CITY OF FISHERS AGENDA

BOARD/COMMISSION: Planned Unit Development (PUD) Committee Meeting
DATE: 8/2/2023, at 5:00 PM
DIRECTIONS: Launch Fishers Theater , 12175 Visionary Way, Fishers, IN 46038

b. **List Bio**
   Case: PUD-23-9
   Address: 9601 E 126th St
   Request: Approval of architecture for a new biotechnology building with associated site improvements within the Sunbeam PUD. Building is located within the Fishers Life Science and Innovation Park.
   Petitioner: List Biotherapeutics Inc
   Planner: Megan Vukusich, vukusichm@fishers.in.us

Planned Unit Development (PUD) Committee Staff Report

2 A101 NORTH ELEVATION
3/32" = 1'-0"

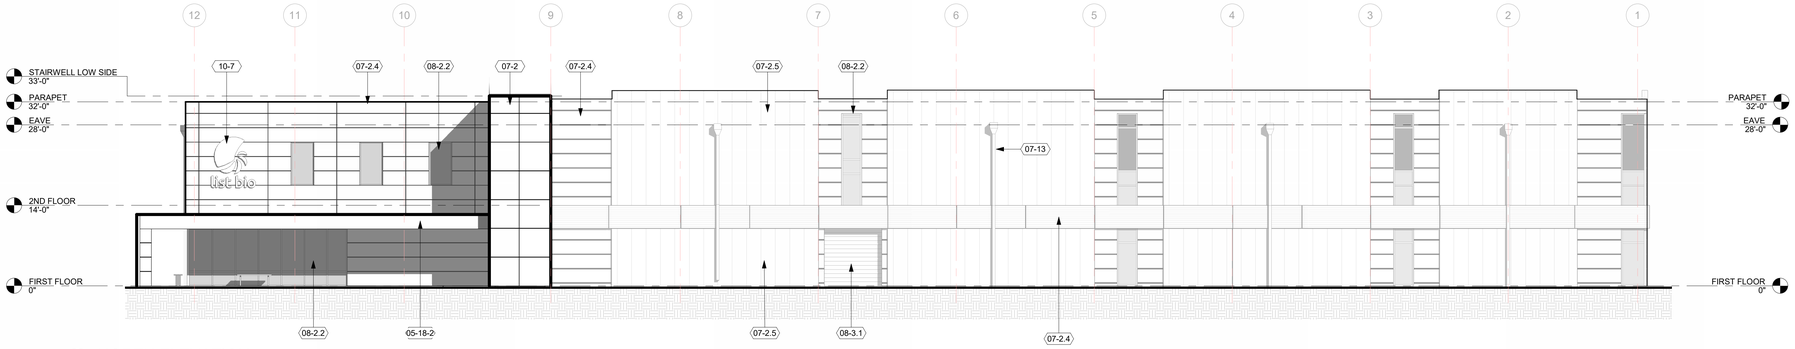
STAFF RECOMMENDATION:
Staff recommends the canopy and glazing elements on the north elevation (facing 126th St) be continued for the entire length of the façade.
